STAFF RECOMMENDATION 1501 Beechwood Avenue August 15, 2012

Application: New Construction—addition
District: Belmont-Hillsboro Neighborhood Conservation Zoning Overlay
Council District: 18
Map and Parcel Number: 11801000600
Applicant: Betsy Pogue
Project Lead: Melissa Baldock, melissa.baldock@nashville.gov

Description of Project: Application is to construct a one-and-a-half story rear addition that is wider than the historic structure.

SIDE STREET ELEVATION

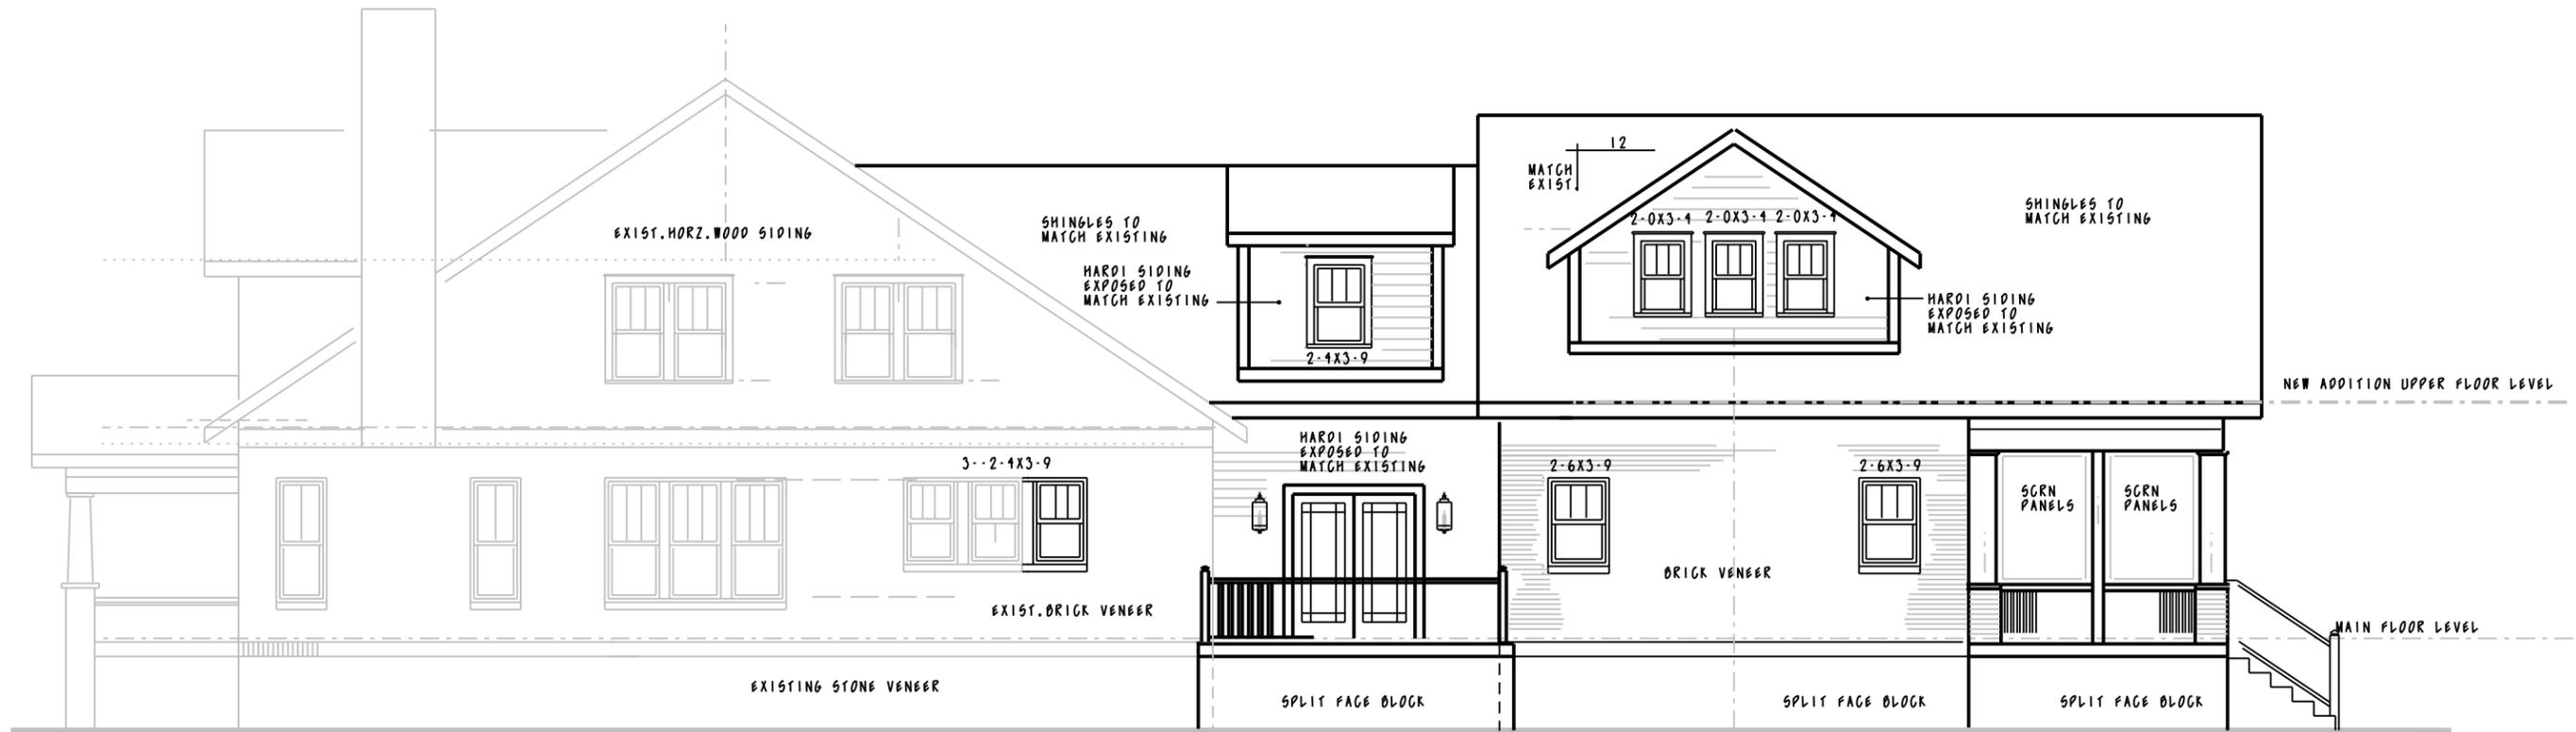
Location and Setback: 1501 Beechwood Avenue is a corner lot, located at Beechwood Avenue and 15th Avenue South. The proposed addition’s left (15th Avenue South) façade will therefore be highly visible. The addition will be located behind the historic house, although it does extend one foot (1’) wider than the historic house for a depth of fifteen feet (15’) (to be discussed in more detail under the “Height and Scale” section).

On the left side, after a depth of thirteen feet, three inches (13'3"), the additions steps back out one foot, six inches (1'6") for a depth of four feet, six inches (4'6"). After that point, a covered side porch extends from the side of the addition and will be one foot (1') wider than the historic house. The covered side porch will have a maximum depth of six feet (6') and will be fifteen feet (15') wide. After the porch, the addition's left (15th Avenue South) side then steps back in and will be inset one foot, six inches (1'6") from the sidewall of the house for the remaining depth of the addition.

Staff finds the fact that a portion of the addition is wider than the historic house appropriate in this instance for several reasons. The design guidelines state that an addition can be wider than the historic structure when the building is narrower than thirty feet (30') or is shifted to one side of the lot. In this instance, the historic house is wider than thirty feet (30') but it is slightly shifted on the lot so that the house is seven feet (7') from the property line on the right side and eleven feet (11') from the property line on the left (15th Avenue South) side. In addition, the guidelines state that a structural alcove that is inset a minimum of one foot (1') and is at least twice as long as it is deep must separate the historic house from the wider portion of the addition. In this instance, there is a structural alcove that is inset three feet (3') and has a length of thirteen feet, three

inches (13'3"). Lastly, the wider portion of the addition is relatively modest in size and scale. It only extends one foot (1') beyond the sidewall of the house, and this portion of the addition is only one-story in height and is an open porch. All of these factors will help minimize the impact of the extra width on the historic house.

Staff finds the height and scale of the proposed addition to meet Sections II.B.1.a., II.B.1.b., and II.B.2.a. of the *Belmont-Hillsboro Neighborhood Conservation Zoning Overlay: Handbook and Design Guidelines*.
